Enclosure 3
NRC Handouts
of the May 2, 2012
ROP Public Meeting

Whitepaper for Drill and Exercise Performance Indicator Criteria Revision

**NRC Comments on
FAQ 12-01 (~~Proposed~~) re. Columbia DG3 Failure
For May 2, 2012 ROP WG Meeting**

Plant: Columbia Generating Station (CGS)

Figure 1, Load and current profile during DG3 Operation on 2/28/10

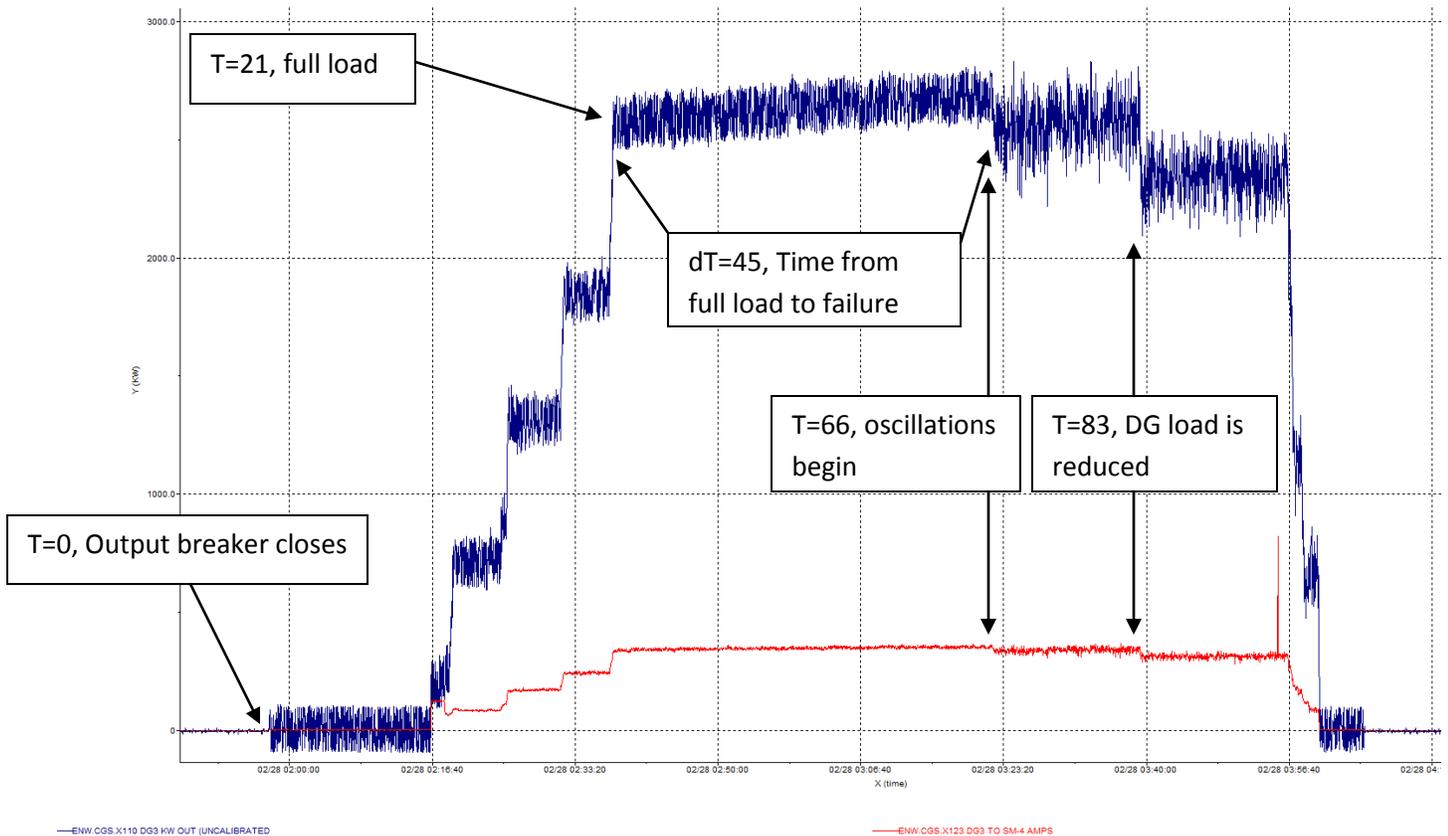
On February 28, 2010, CGS was testing an Emergency Diesel Generator (EDG). Refer to figure 1 for Load and Current trace of the subject event. The EDG successfully started, the EDG output breaker successfully closed (T = 0 minutes), the EDG successfully load sequenced up to fully loaded (T = 21 minutes), after 45 minutes the EDG experienced unexpected load oscillations of 350 kw (T = 66 minutes), after 17 minutes the load was lowered (T = 83 minutes) and the 350 kw oscillations were observed to continue another 16 minutes of operation until the EDG was unloaded (T = 99 minutes) and shut down.

CGS and the CGS NRC Senior Resident Inspector (SRI) do not agree that CGS properly reported the February 28, 2010 EDG failure. NEI 99-02 defines “EDG failure to load/run”. In part, it states: “Given that it has successfully started, a failure of the EDG output breaker to close, to successfully load sequence and to run/operate for **one hour** to perform its monitored functions.” The intent of this FAQ is to clarify that based on the guidance available at the time the start time for the “one hour” period begins once the EDG has completed its load sequence and is loaded (at T=21 and not at T=0 (as per figure 1)). Based on the response to FAQ Number 487, CGS understands that as of 1/1/2012 the “one hour” period begins at output breaker closure (T=0 per figure 1).

Regardless of the time the 1 hour clock started, the resident inspectors believe that this failure should be consider as an “EDG failure to run”. Plant data revealed that at 3:22 AM, DG-3 began to exhibit degraded performance but still provided an average (based on 1 minute average) of >2547 KW which is sufficient to meet all post-accident loads. The diesel engine was allowed to continue to operate until about 3:42 AM when the control room operators logged that after running DG-3 fully loaded for **over an**

hour (emphasis added), the component exhibited load swings of 200-300 KW. The component was secured due to the degraded performance shortly after the operators logged the issue with DG-3. Since the component continued to operate after observing the degraded performance, it is not clear if the monitored function was immediately lost or if the component would have continued to operate for its required mission time. To date, the licensee has not performed an engineering evaluation of the degraded condition to determine at what point the monitored function was lost. The inspectors believe that a strong case can be made that a run failure should be assigned based on NEI 99-02, Revision 6, Page F-28, Lines 28-31

once the EDG has completed its load sequence and is loaded (at T=21 and not at T=0 (as per Figure 1)). The licensee's proposed resolution would contradict the FAQ 11-08 resolution and could result licensees reclassifying past EDG failures in a non-conservative manner, which would be unacceptable to the NRC. FAQ 11-08 reflects the intent of the guidance in effect at the time of this failure.

FAQ 11-08, which improved and clarified the EDG failure characterizations, became effective starting with 1Q2012 PI data (after the EDG failure in question at Columbia). Despite the FAQ approval and effective date and the ambiguity of the NEI 99-02 phrasing in effect at the time of the EDG failure, it was the intent of the Revision 6

guidance in effect at the time of the EDG failure in question (i.e., the guidance in effect before approval of FAQ 11-08) to consider this EDG failure as a failure-to-run. The basis for this decision is described as follows.

Because the EDG definitions guidance in NEI 99-02 prior to FAQ 11-08 needed improvement and clarification, the NRC staff evaluated this issue based on the characteristics of the EDG failure (i.e., the functional response of the EDG and the failure mechanism), the intent of the NEI 99-02 guidance at the time of the failure, and applying reasonable decision-making given the guidance in effect at the time of the failure. The oscillations were caused by foreign material in the governor – a condition which had existed for several years and which did not impact prior breaker closure and sequencing operations. Figure 1 in this FAQ shows that the oscillations did not occur during the breaker closure or the load sequencing or gradual loading action. Rather, the oscillations occurred 66 minutes after breaker closure and 45 minutes after the full load (for purposes of the test run) was achieved, which is indicative of a challenge to the EDG’s ability to continue to run for its mission time. Even though the foreign material existed in the governor for several years, the EDG had started and load sequenced several times without failure. Therefore, this failure appears to have been exacerbated by the running of the EDG.

Because Figure 1 data is more reflective of an EDG failure-to-run for its mission time rather than a loading failure and the intent of NEI 99-02 at the time of the failure was clarified via FAQ 11-08, the EDG failure at Columbia should have been reported as a failure-to-run. The staff would have reached the same decision prior to the existence of FAQ 11-08 if the issue had been raised at the time; therefore, this decision does not contradict the footnote on page 3 of NEI 99-02.
